# TriCounty Watchdogs

**Re: Comments on the Newhall Ranch EIR/EIS for the 404 Permit and Streambed Alteration Agreement**

**042. Letter from TriCounty Watchdogs, dated August 22, 2009**

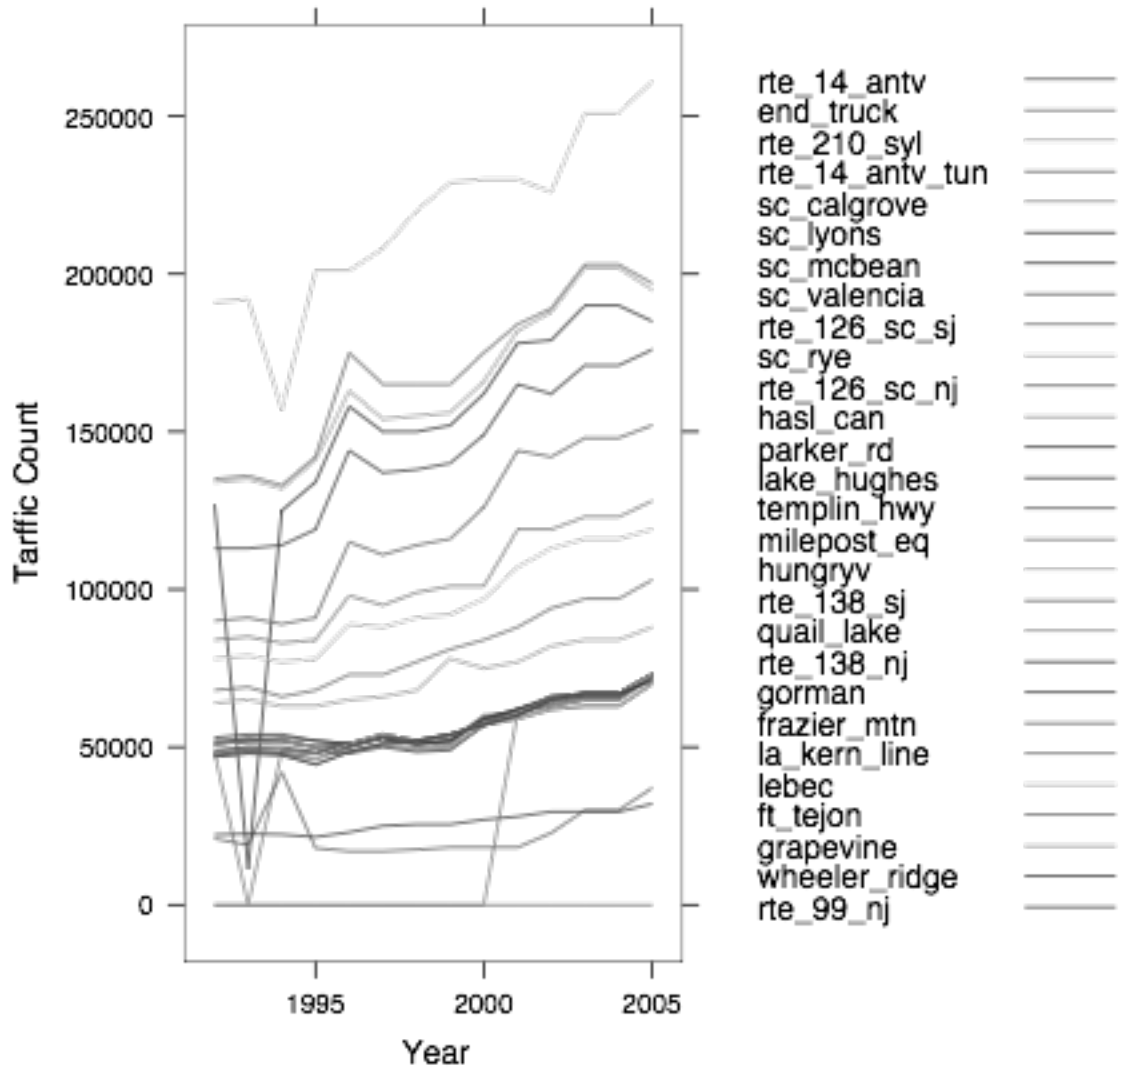
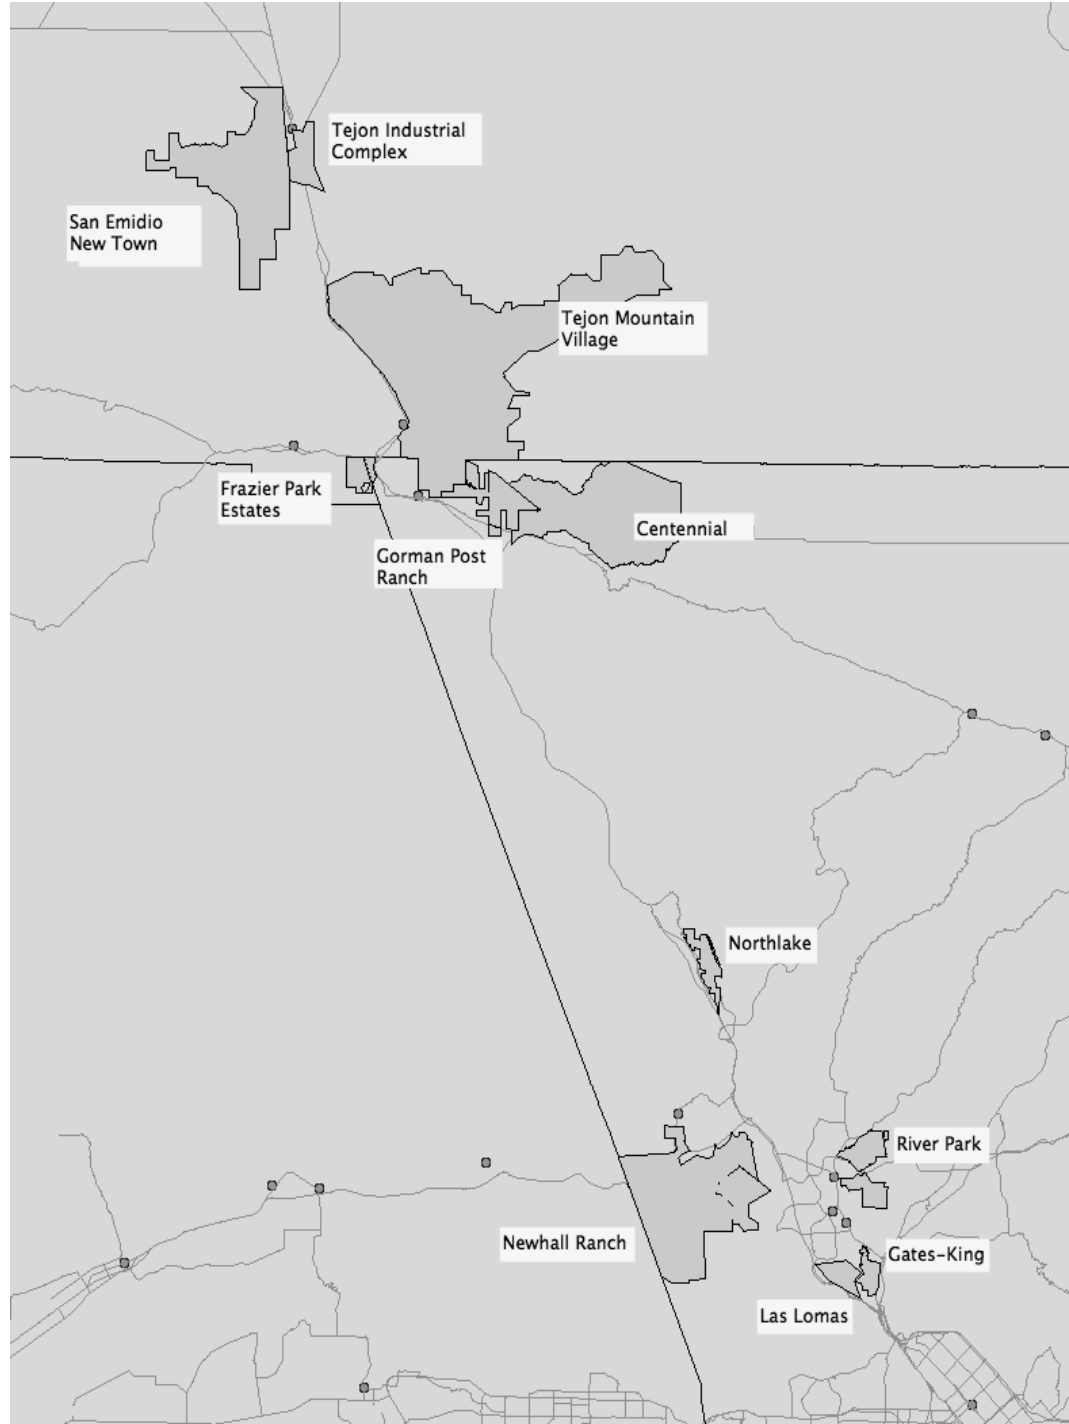
In the cumulative traffic impact section the DEIR only pays attention to projects that are "reasonably expected to be in place in 2007" and that are in the Santa Clarita area. That seems short-sighted, both in time and space. The GIS map in Figure 2 at the end of this letter shows planned developments, some of it with approved specific plans, that will impact traffic in the corridor between Castaic and the North San Fernando Valley. Centennial, 30 miles north of the project, will generate 400,000 ADT's at buildout, and it seems reasonable to assume that at least 50,000 will head south on I-5, and all of these will cross the intersection with SR-126. It is true that Centennial and similar projects have not yet been approved, and will take 25 years to completion, but it is certainly not proper planning to act as if they do not exist. SCAG and MTA to some extent take these projects into account in their long-term plans for Northern LA County traffic.

As such, the year 2030 traffic forecasts include traffic generated by each of the regionally significant planned developments shown in the comment exhibit, including Centennial, Gorman Post Ranch, Frazier Park Estates, Tejon Mountain Village, Tejon Industrial Complex, Northlake, River Park, and Gates-King, but with the exception of the Las Lomas development. As of this writing, the development application for the Las Lomas development has been pulled, and the City of Santa Clarita's official position is in opposition to the project; for that reason, neither the City of Santa Clarita nor the County of Los Angeles have included the project in their long-range planning horizons.
